Dragonclaw v0.2 1.8V Load Switch Rework

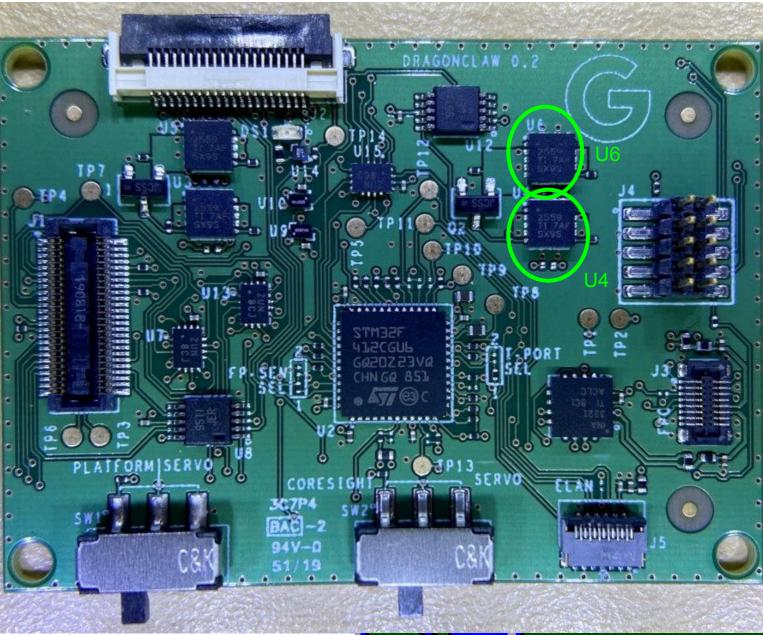
Remove U6 and U4. Replace with FPF2125.

Right-align FPF2125 with existing footprint.

Vout and Iset line up with the right side pads.

GND lines up with the center ground pad.

Lift up the Vin and ON legs and use small wire to connect it to the left pads.
